工程指示 / 要求簡箋(E.I.)

工程指示編號：EI / 3037 / 21

工程編號：J - 852

工程名稱：亞皆老街中電

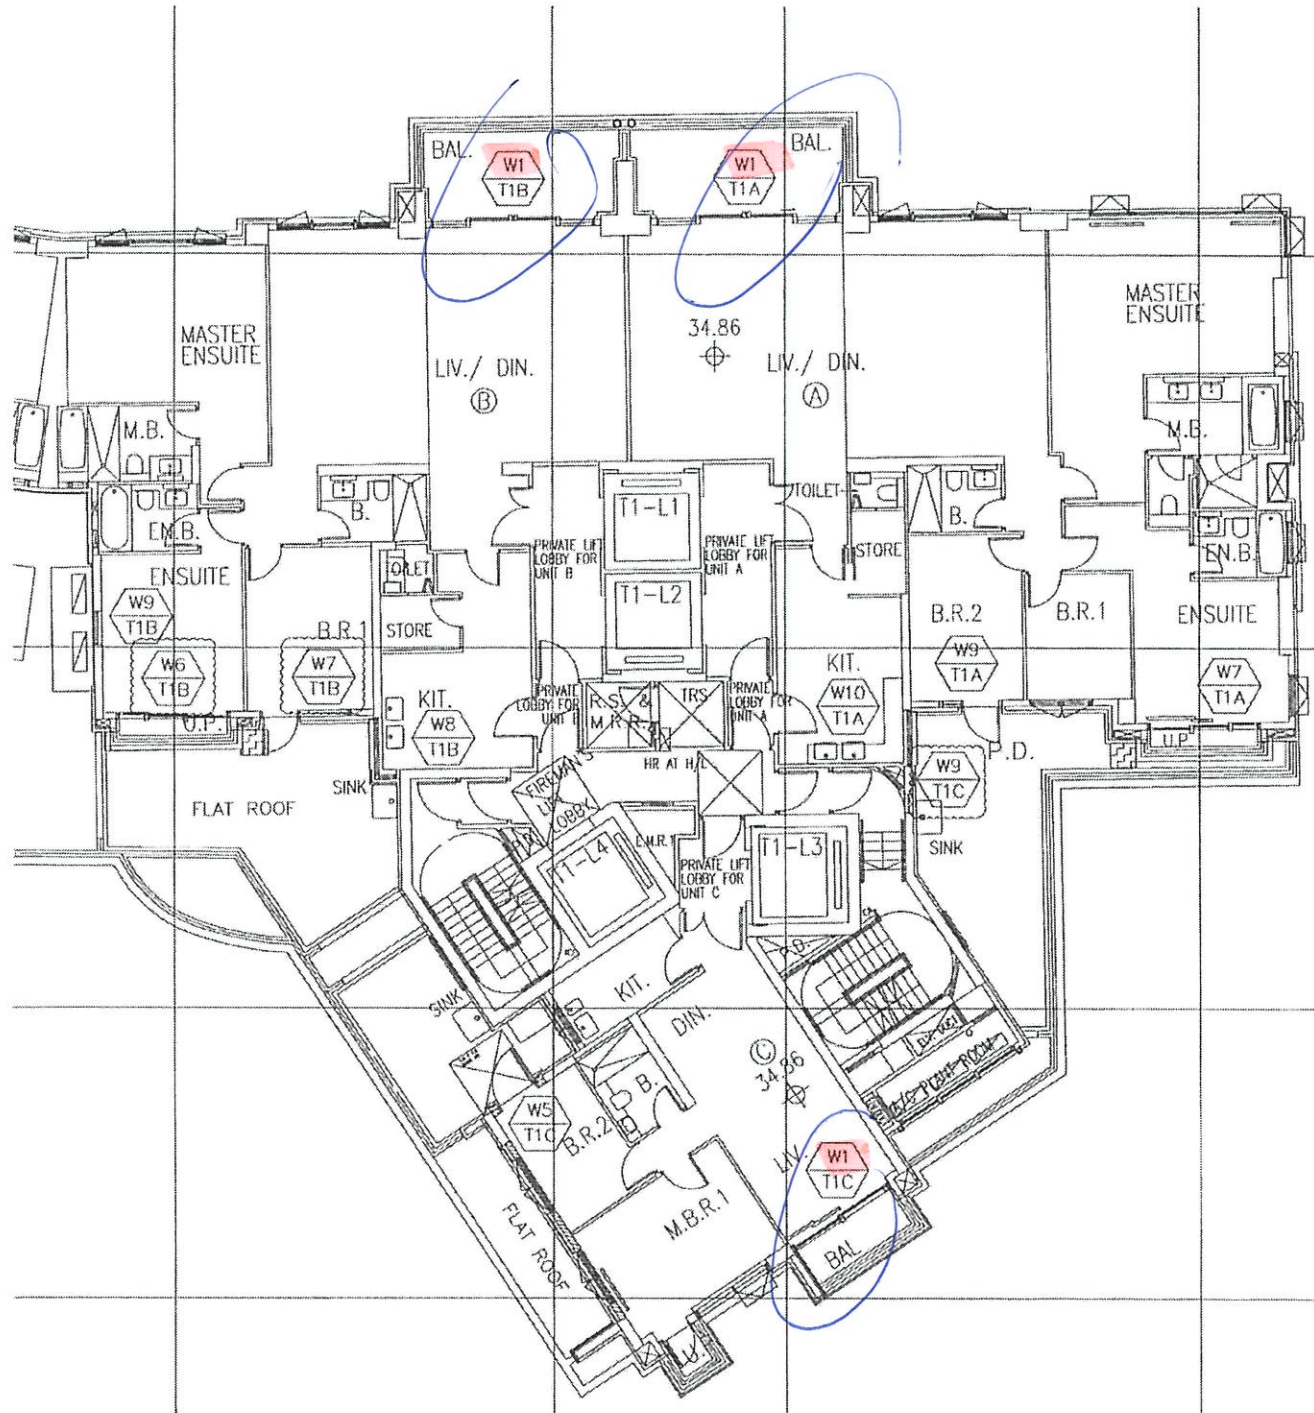
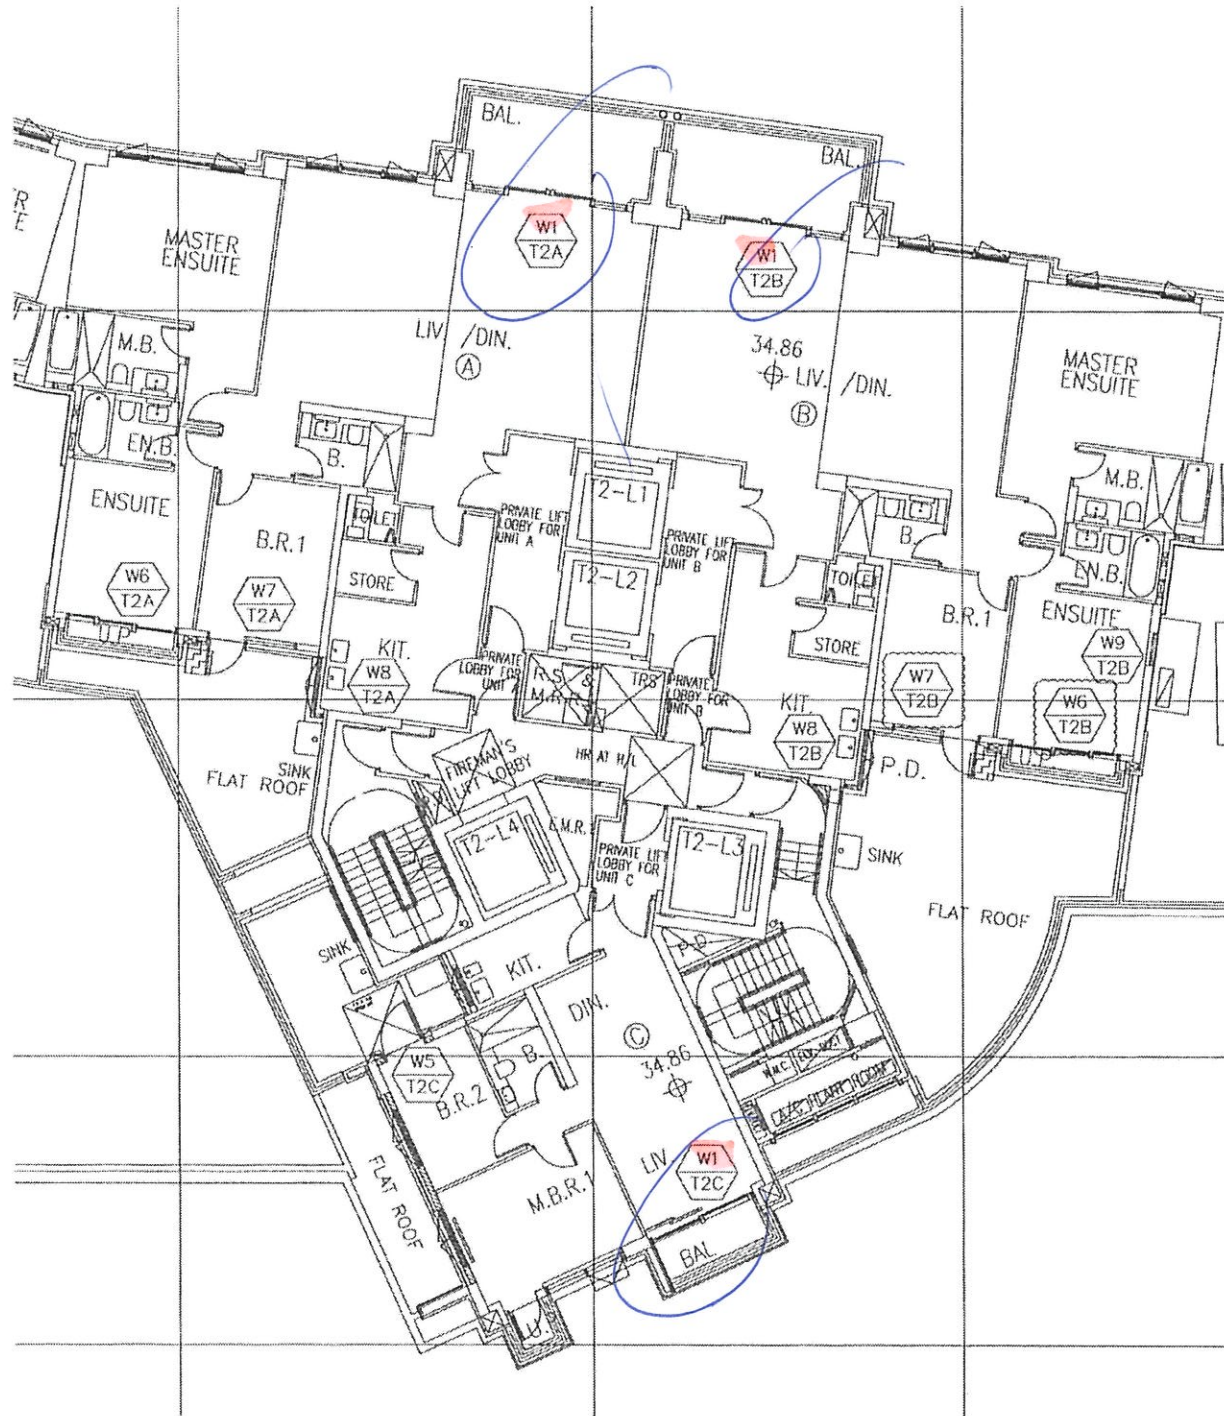
Q 版: 因地盤消防 LIFT 已啟用，門玉用 LIFT 上料，現可組裝門玉(整幅)出貨，T3 優先組裝出貨

P 版: 放行 W1/T1/2/3/C 門玉生產，已覆查是按批圖設計

O 版: 按現場實際安裝，W1/T1/2/3C 的門玉闊度細了 10mm，請暫停生產 W1/T1/2/3C (C 廳) 的趟門玉。

M 版: 按現場實際安裝覆數，所有門玉加力通高度縮減 20MM 及過孔有修改，請按加工圖生產

K 版: 按現場實際安裝覆數，所有門玉高度縮減 3mm。現提供修改 T1-T3 門玉完整加工圖，另提供修改 T1-T3 完整門玉開料單

J 版: W1/T1A/B/C, W1/T2A/B/C, W1/T3A/B/C 門玉請不要全組裝好。請組 L 型，拉手企跟底橫組裝。

I 版: 已修改 W1/T3A/B/C 趟門拉手高度

G/H 版: 已修改防撞膠粒的孔位

F 版: T3 趟門玉高度縮短 3mm，另提供 T3 門玉開料單

E 版: 更正沙基位位置，W6/T3B 及 W6/T1B 是沙基位，門玉先生產但請不要出貨，待地盤通知
